January 3, 2017

ADDENDUM NO. ONE to the plans and specifications for the FARMINGTON PUBLIC SCHOOLS, 2018 RENOVATIONS ELEMENTARY SCHOOLS, Farmington, MI, Architect's Project No. 171712A, dated November 21st, 2017.

The above plans and specifications are modified, supplemented or augmented as follows, and this ADDENDUM NO. ONE, is hereby made a part of the contract documents.

C3.1

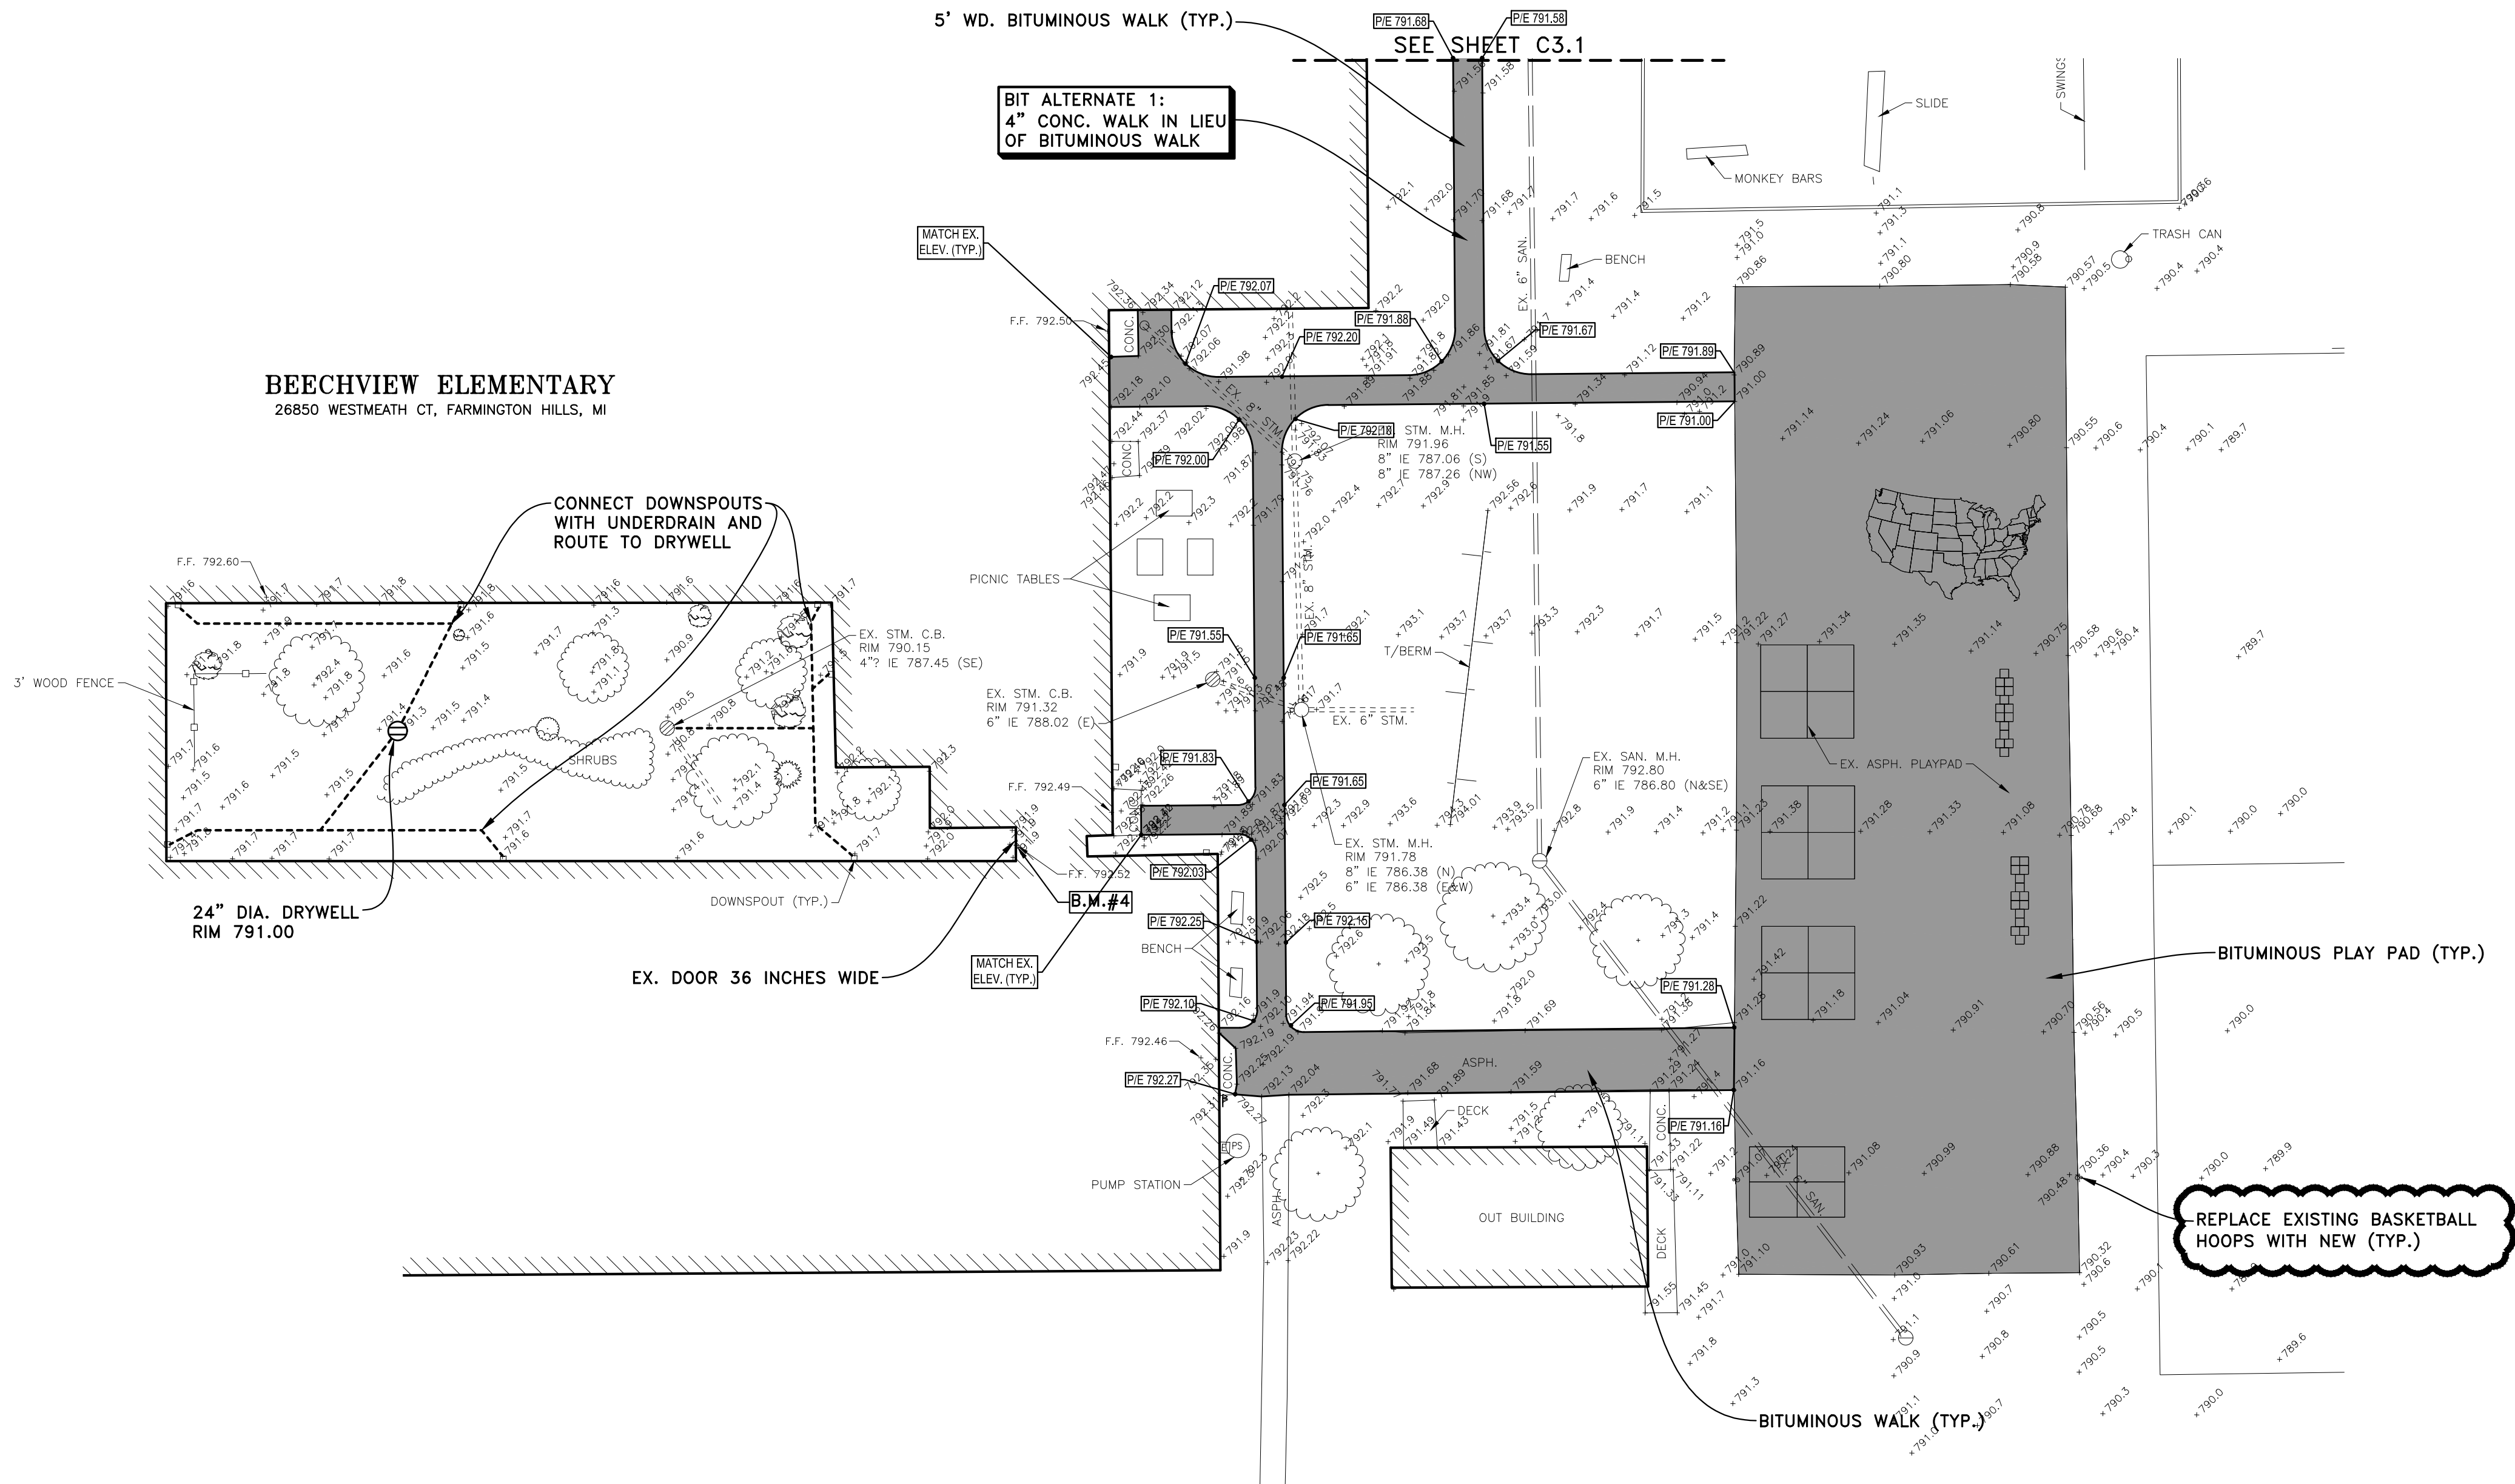
- ITEM NO. C1:** Refer to Drawing No. C2.0 (Re-issued):
a. Removed waking path alternate.
- ITEM NO. C2:** Refer to Drawing No. C3.1 (Re-issued):
a. Revised sidewalk layout.
- ITEM NO. C3:** Refer to Drawing No. C3.2 (Re-issued):
a. Revised playpad scope.

1
A2.2BV
ENLARGED AREA "B" REFLECTED CEILING PLAN
SCALE: 1/8" = 1'-0"

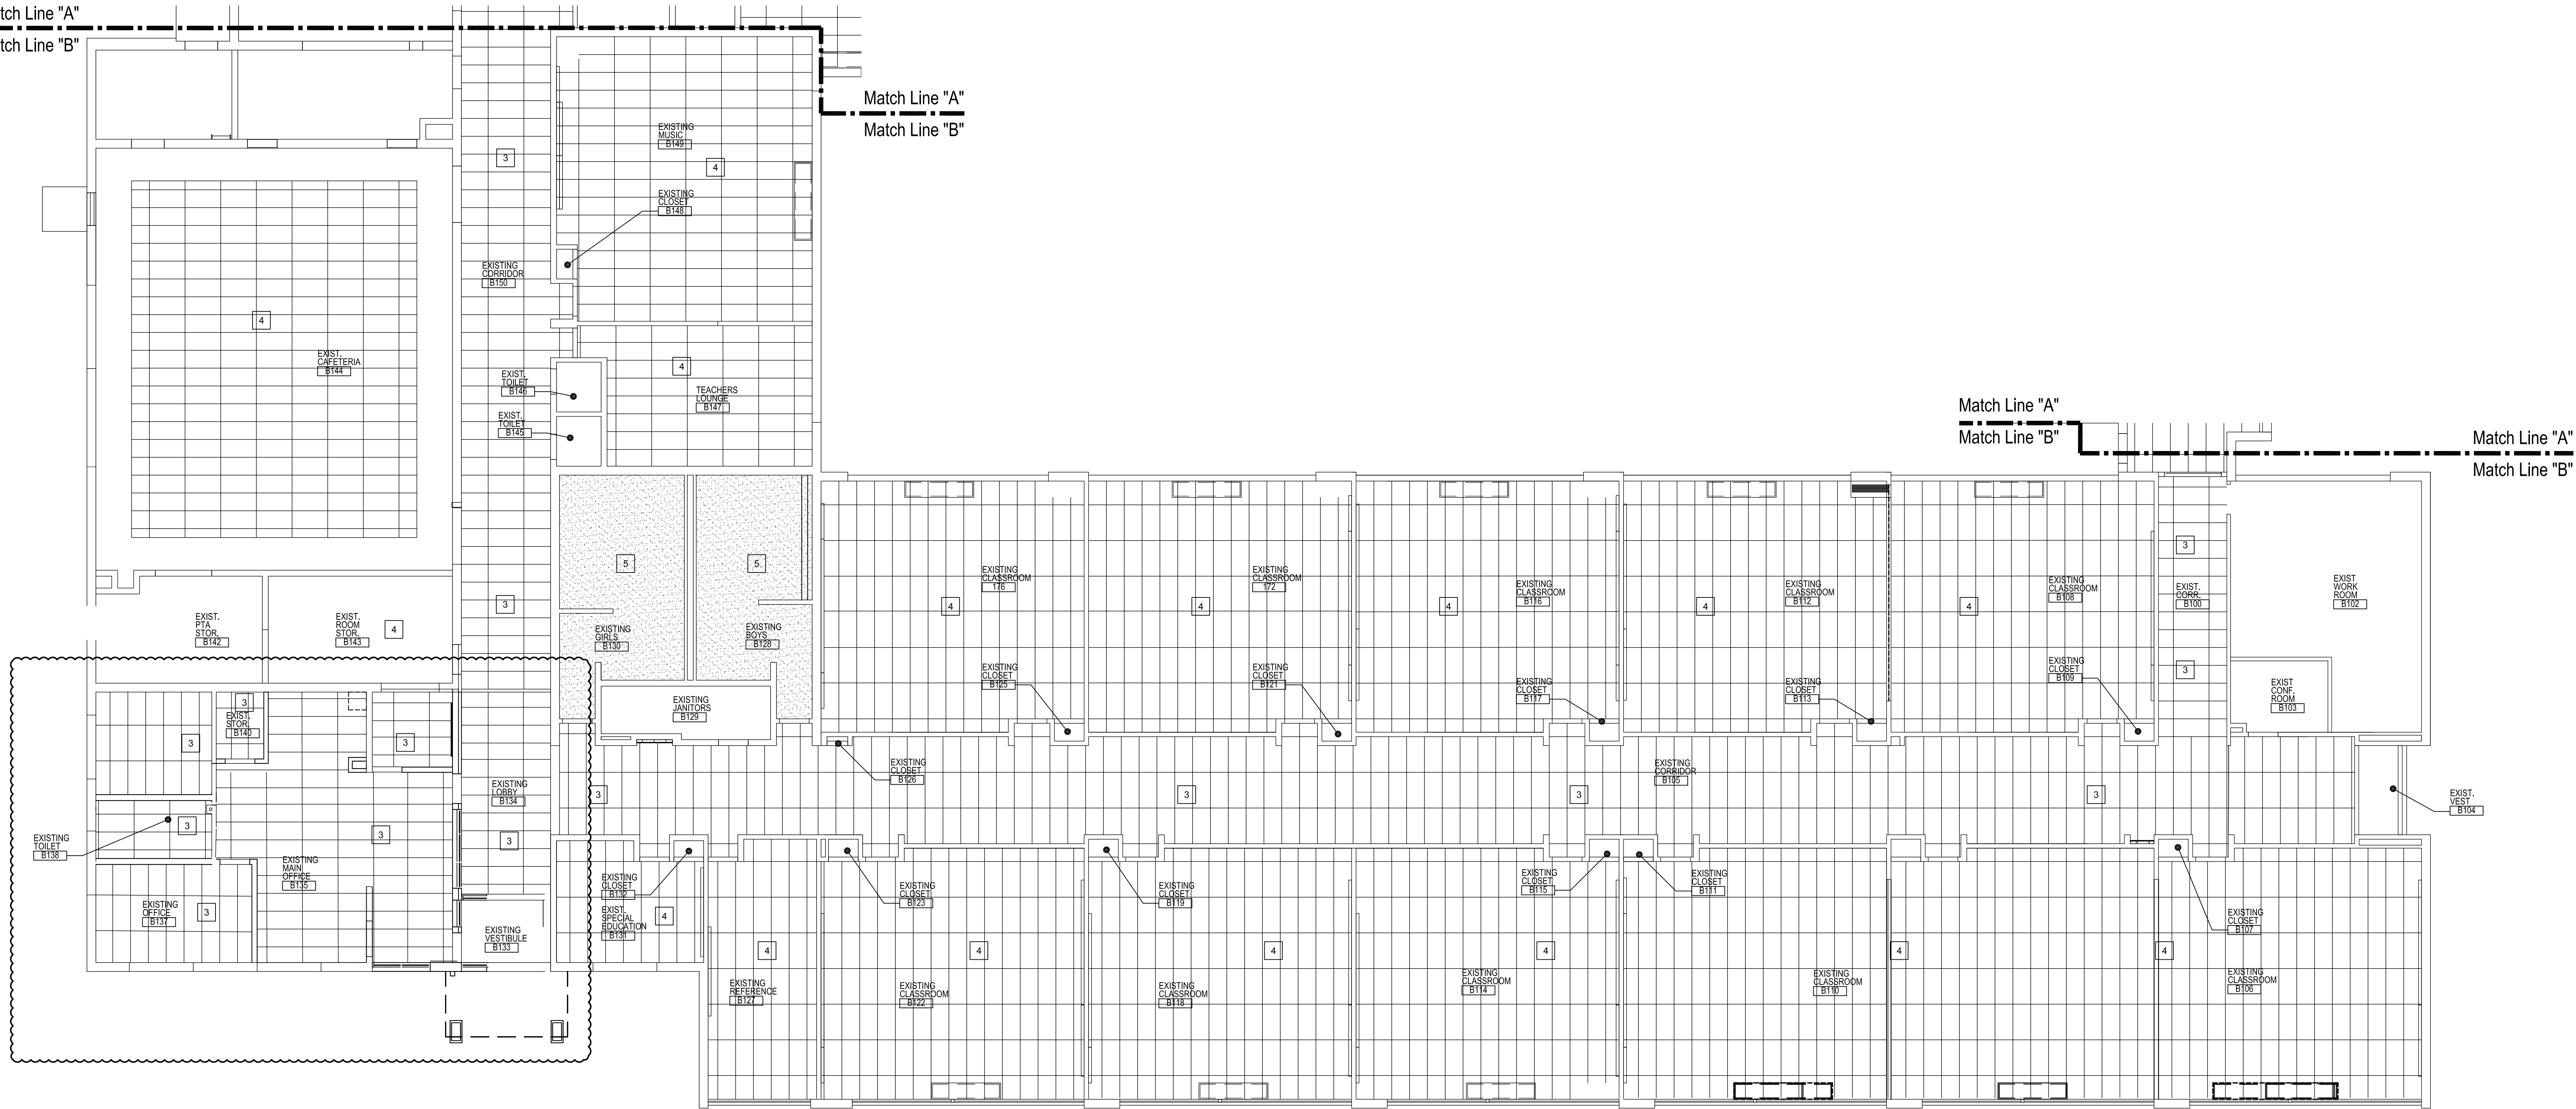
- ITEM NO. A6:** Refer to Drawing No. A2.2BV (Re-issued):

- a. Revised new ceiling grid.

12 COLUMN DETAIL
SCALE: 1 1/2" = 1'-0"

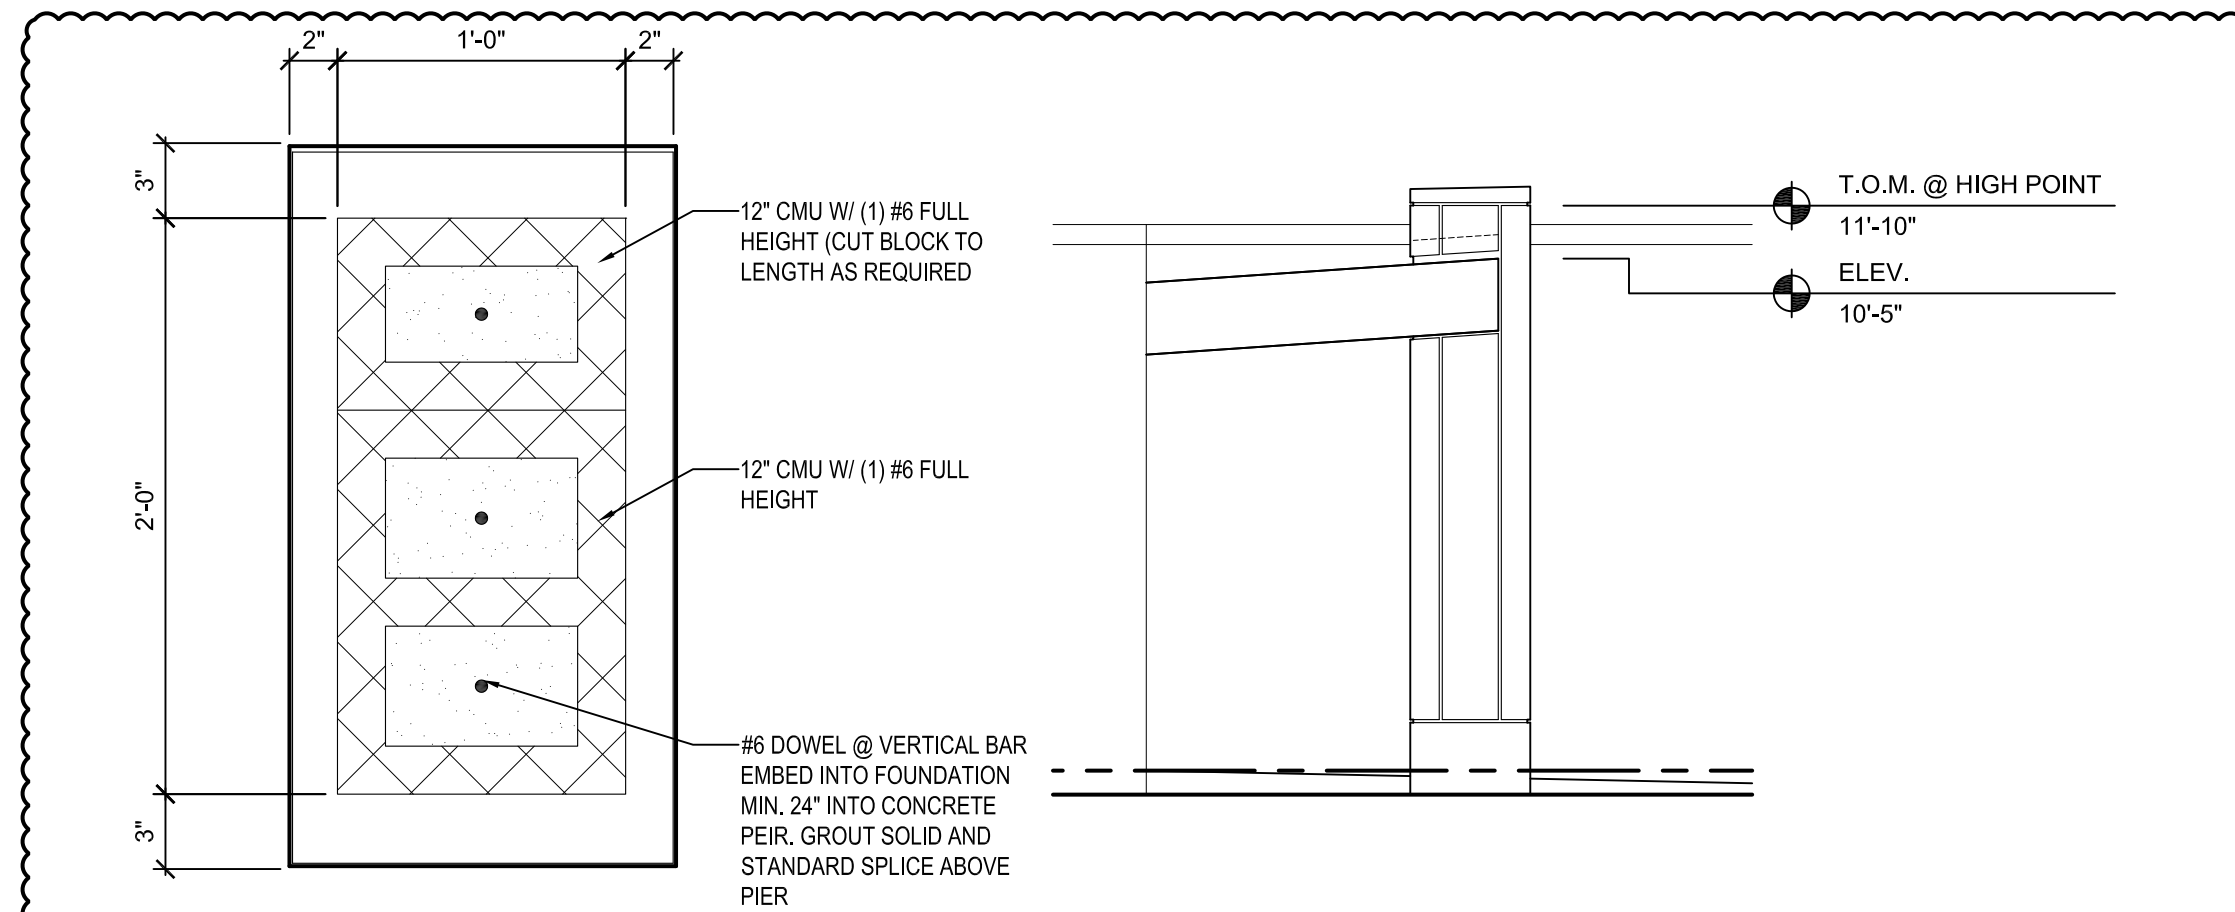
- ITEM NO. A9:** Refer to Drawing No. A5.1BV (Re-issued):

- a. Updated side elevation @ new entry 4/A5.1BV
- b. Updated column detail 12/A5.1BV
